ATTENTION: Eliotte Walford-Smith
Application Reference: A006769246
Address of Site: 48 WOODSTOCK AVE TARINGA QLD 4068

RE: Further advice

Figure 1 – Required section drawings

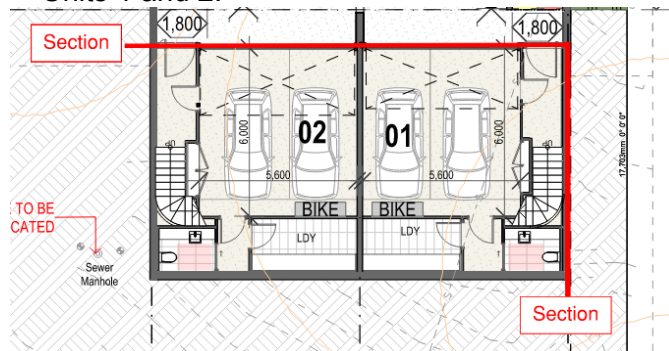
- 1) A full assessment in relation to the building envelope and its visual dominance has not been undertaken due to information not being provided.
 - a) Provide sections as shown in Figure 1 to provide clarity on the height of the proposed Units 1 and 2.
